NORTHEAST UTILITIES

Docket No. 50-423
B11367

Millstone Nuclear Power Station, Unit No. 3
Use of Alternative Damping Criteria

Figure 3.7B-71

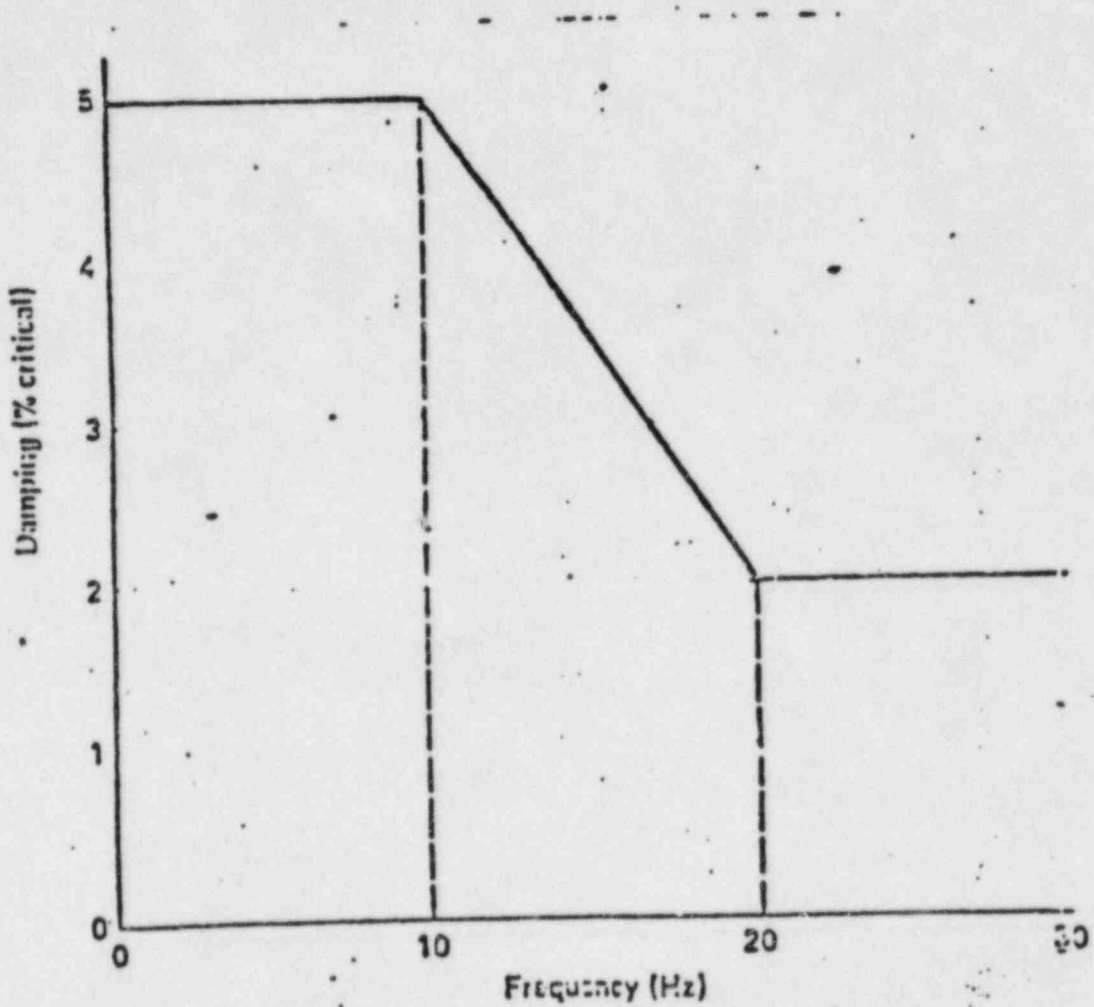
As suggested by the Mechanical Engineering Branch (MEB) at a meeting with representatives of Northeast Nuclear Energy Company (NNECO) on September 13-14, 1984, NNECO hereby submits its intention to change the modal damping values utilized for the dynamic analysis of piping systems. The FSAR currently specifies the use of ½% damping for the Operating Basis Earthquake (OBE) and 1% damping for the Safe Shutdown Earthquake (SSE) events. NNECO proposes to utilize the damping curve developed by the Pressure Vessel Research Council (PVRC) in ASME code case N-411 for both OBE and SSE events. The increased damping values provided by the PVRC curve will be utilized during our stress reconciliation program (i.e., finalization of pipe stress analysis or piping systems backfits) in order to avoid costly and schedule sensitive pipe support modifications due to conservatively developed seismic loads. The necessary FSAR changes are attached, and will be included in a subsequent Amendment to the FSAR.

Obtained for discrete locations in the structure where the piping systems are supported. Enveloping and peak broadening procedures are applied on these ARS curves before input, as described below. Damping values used for piping are 0.5 percent for OBE and 1 percent for SSE (Section 3.7B.1.3), except that increased damping values may be applied on an as-needed basis for final stress reconciliation (or piping system backfits) in accordance with ASME Code Case N-411 (Figure 3.7B-71).

* For final reconciliation of pipe stress analysis or piping system backfits damping values as defined in ASME Code Case N-411 (Figure 3.7B-71) may be utilized for both OBE and SSE.
